ILLINOIS POWER COMPANY

May 29, 1985

Subject: Clinton Power Station Unit #1  
Independent Design Review

The following advanced copies of the Final Safety Analysis Report (FSAR) changes address commitments made for the following Observation Reports:

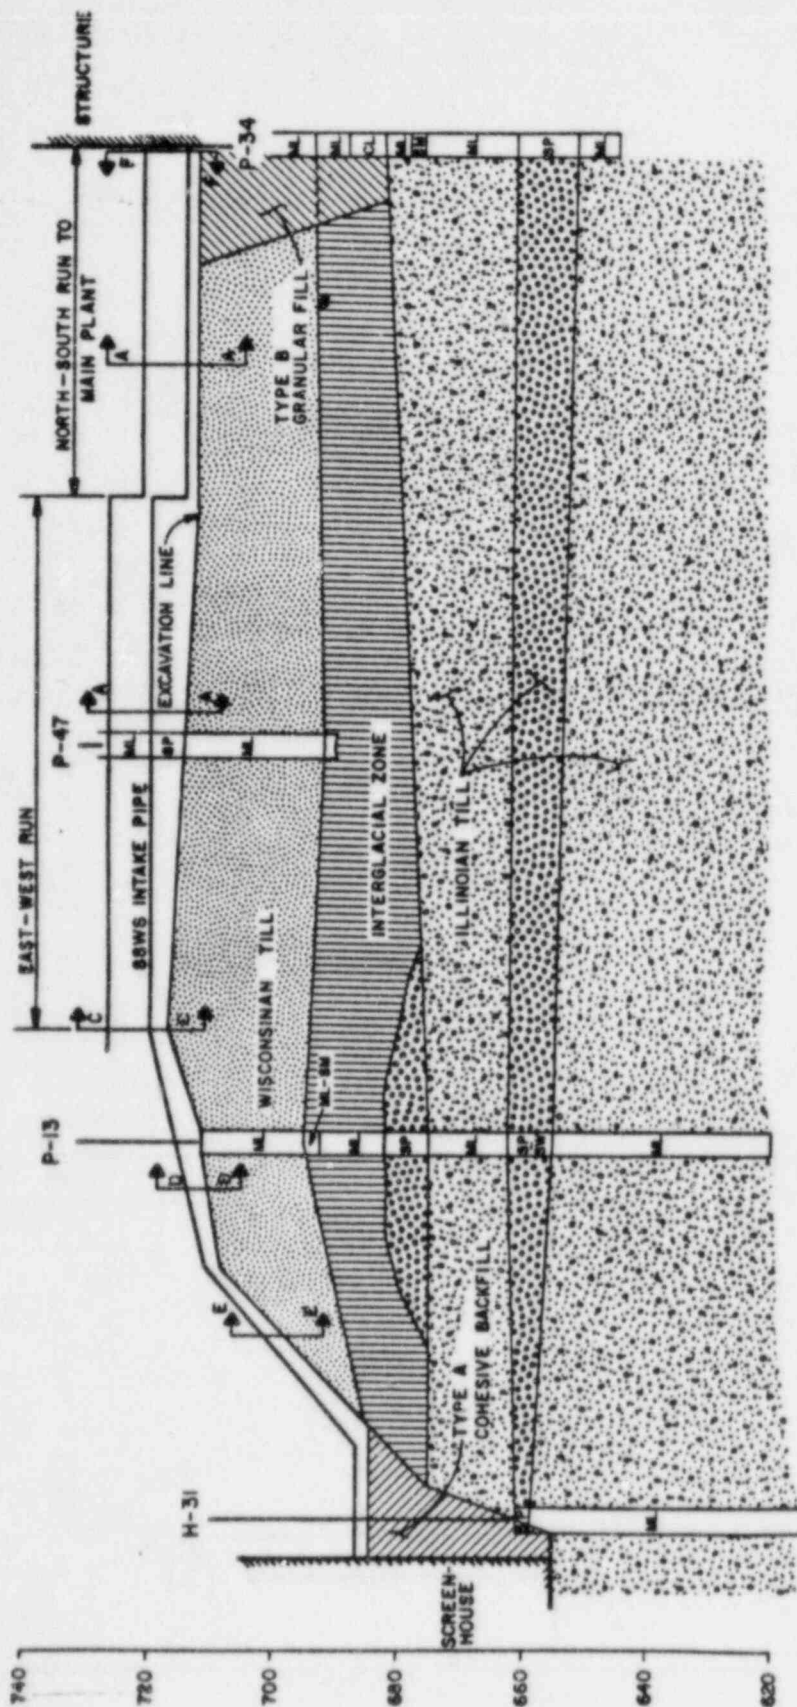
(a) Provide a longitudinal subsoil profile along the ECCS Pipeline from the Screen House to the Station and from the Station to the Outlet structure. Show the zones of soft material and loose material which were replaced by competent material during construction. (b) Provide transverse cross sections showing the pipe, concrete mudmat, and all backfill materials, (c) Show details of backfill and placement near the connection between pipes and structure. What are the estimated total and differential settlement of these points? (d) Provide a figure similar to Figure 2.5-376 for ECCS pipe between the station and ECCS outlet structure.

This question is assumed to apply to buried shutdown service water system (SSWS) piping outdoors. There is no ECCS piping buried outdoors.

- (a) A longitudinal subsoil profile along the SSWS pipeline is presented in Figures 1 and 2. The excavation line for the pipeline is illustrated. The zones of soft and loose material that were removed are shown as over-excavation beneath the pipeline. (Overexcavation is considered to be any excavation greater than 1.5 feet below the bottom of the lower pipe).
- (b) Transverse cross sections showing the pipe, concrete mudmat, and all backfill materials are presented in Figure 3.
- (c) The details of the backfill placement near the connection between pipes and structure are shown in Section F-F of Figure 3.

The estimated total settlement for the structure (Diesel Generator Building) where the SSWS pipes enter is 1 inch. This settlement is based on the estimated total settlement of the structure (Figure 2.5-436) beginning January 1, 1979. This is the approximate date of the connection of the first pipe to the structure. If it is assumed that the pipeline will not settle, the estimated differential settlement between the pipeline and structure will also be approximately 1 inch.

- (d) A figure showing the fly ash placement from the SSWS outlet structure and along the pipeline to the main plant is shown in Figure 4.

(See revised Figure 2.5-376.)
